Addendum No: One (1)
Project: Iowa High School – Hurricane Laura Repairs
Project No: HL-026-01
Date: September 25, 2023
To: All Plan Holders

IOWA HIGH SCHOOL: HL-026-01
HURRICANE LAURA REPAIRS
401 W. MILLER AVE.
IOWA, LA 70647
MECHANICAL SCHEDULES AND DETAILS

MP
1.3R

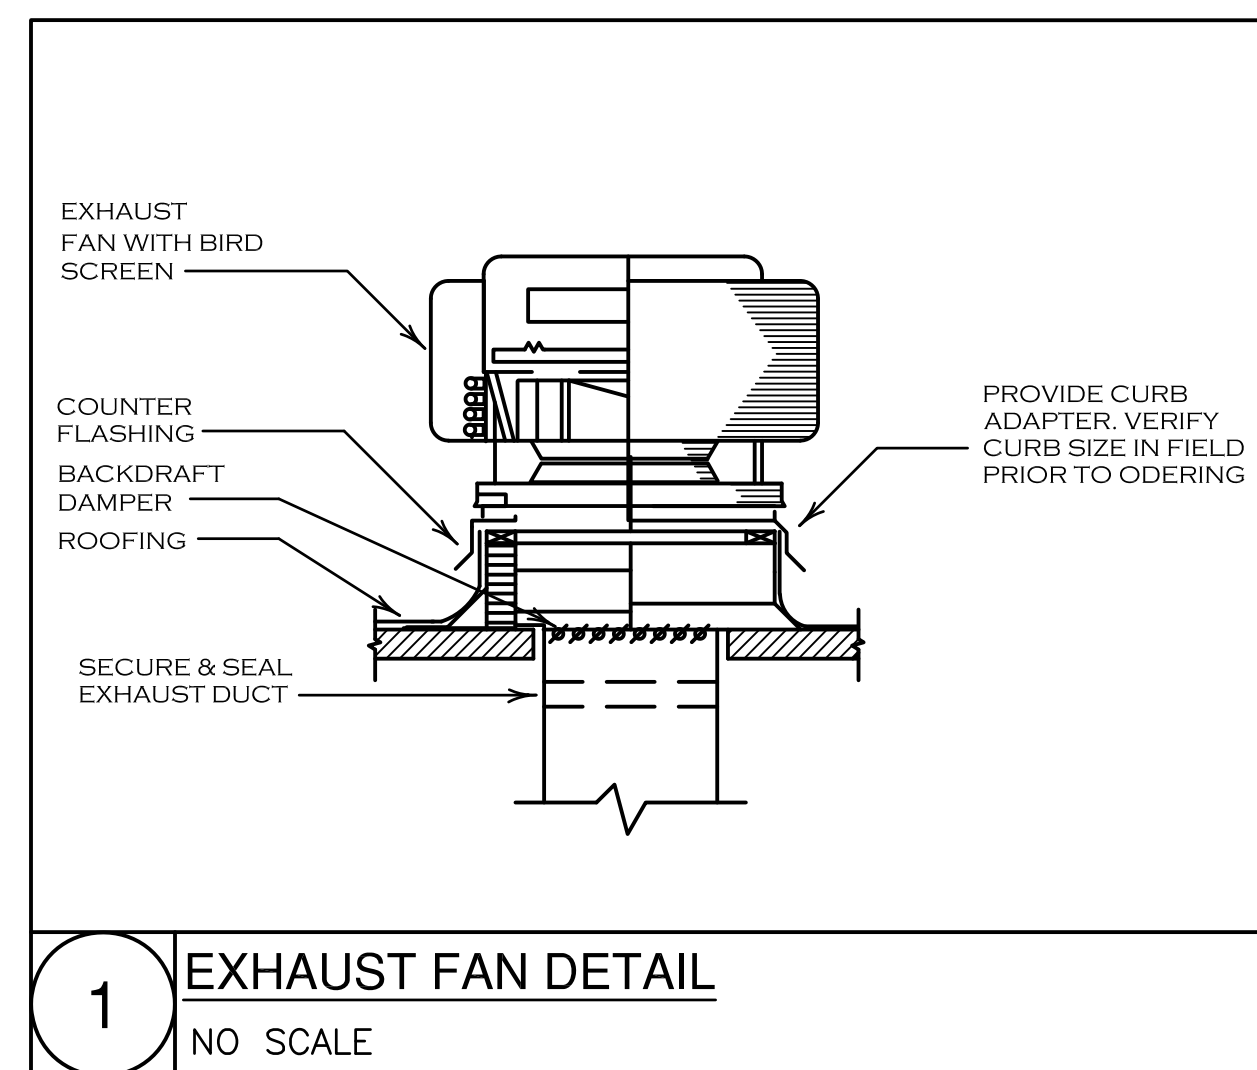
- 18) **SHT MP 1.3R - MECHANICAL SCHEDULES AND DETAILS (REVISED)** (see attached).

- 19) **SHT MP1.1 – MECHANICAL & PLUMBING SITE - CAMPUS**
 - a. Mechanical contractor shall determine what EF-7 serves and report to engineer space/device served or if fan is abandoned prior to submitting shop drawings.
 - b. Exhaust fan curb adapters shall be insulated.
- 20) **SHT MP1.3R – MECHANICAL SCHEDULES (refer to attached sheet)**
 - a. Provide exhaust fans as scheduled in the updated MP1.3R sheet.
